# Product Change Notification

**Change Notification #:** 113329 - 00  
**Change Title:** Intel® Server System R2308GZ4GS9  
PCN 113329-00, Product Design  
Update the System Rear Panel, Resistors,  
Capacitors and BIOS/ME/BMC/FRUSDR  
Firmware  
**Date of Publication:** October 22, 2014

Figure One

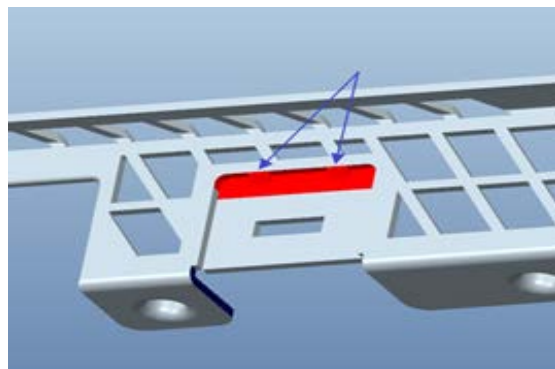
1. Update the one big center joint to two smaller joints so that the joints will not conflict with the LAN cable connector latch. See the Figure One.

Figure Two

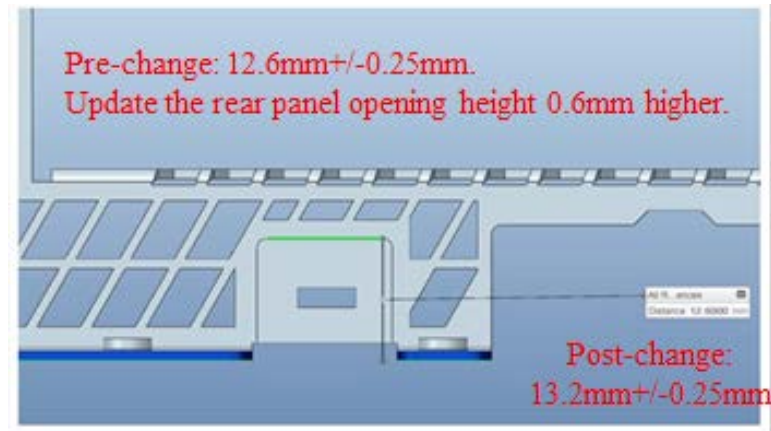
- Update the rear panel opening height 0.6mm higher to improve the flexibility for the cable latch. The previous height was 12.6mm $\pm$ 0.25mm. The updated height is 13.2mm $\pm$ 0.25mm. See the Figure Two.

Figure Three

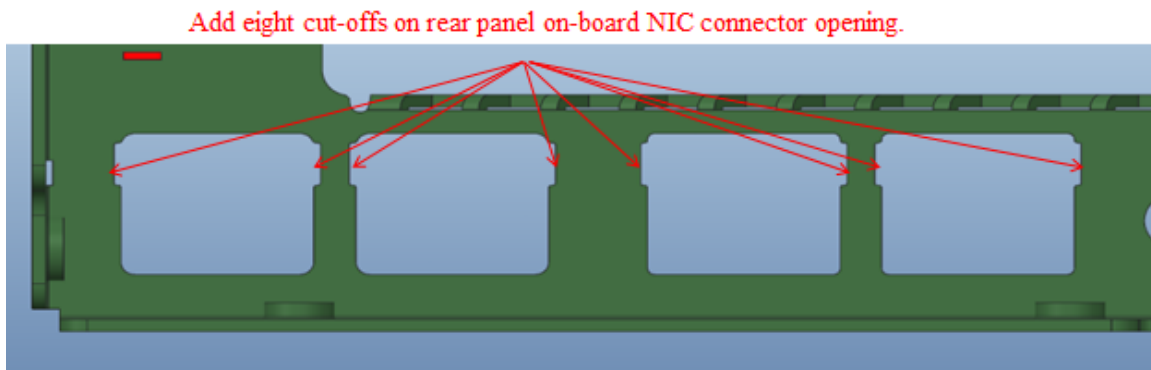
- Add eight cut-offs around the on-board NIC (Network Interface Controller) openings to improve the LED visibility. See the Figure Three.

Figure Four. Component Locations for the 2U Riser Spare A2UL8RISER

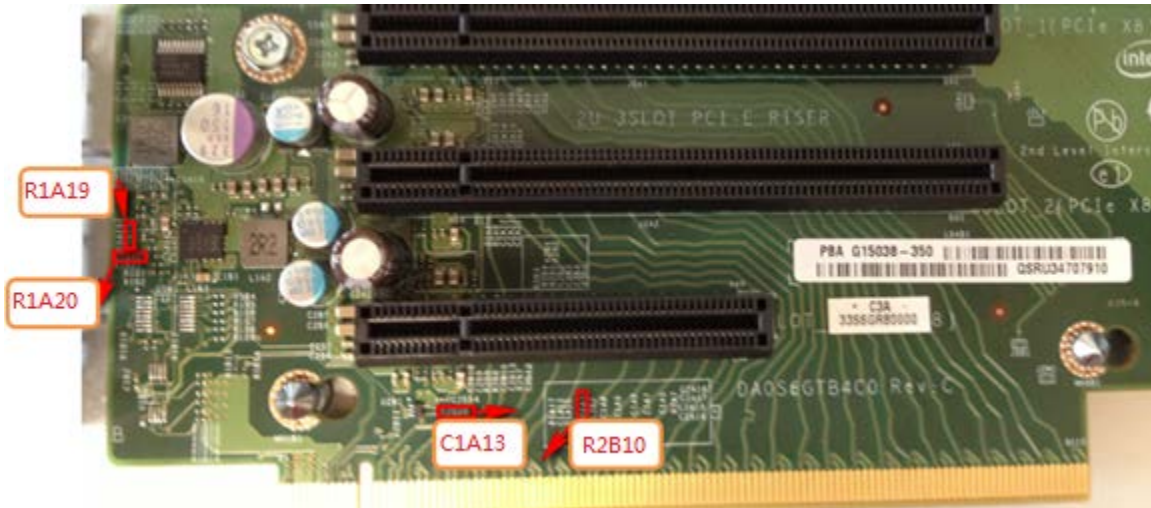
- Update the following resistors and capacitor (see Table One and Figure Four) on the 2U PCIe Riser Spare A2UL8RISER to make an improvement to support a higher 3.3 Voltage Regulator startup over current. Before this change, the Voltage Regulator on the riser card may not be able to turn on when the total current drawn is more than 5A current. After this change, the Voltage Regulator on the riser card can support more than 10A current.

Component	Location	Pre-change	Post-change
Resistor	R2B10	10.0 kOhm	3.65 kOhm
Resistor	R1A20	0 Ohm	30 Ohm
Resistor	R1A19	40.2 kOhm	20 kOhm
Capacitor	C1A13	10 pF	120 pF
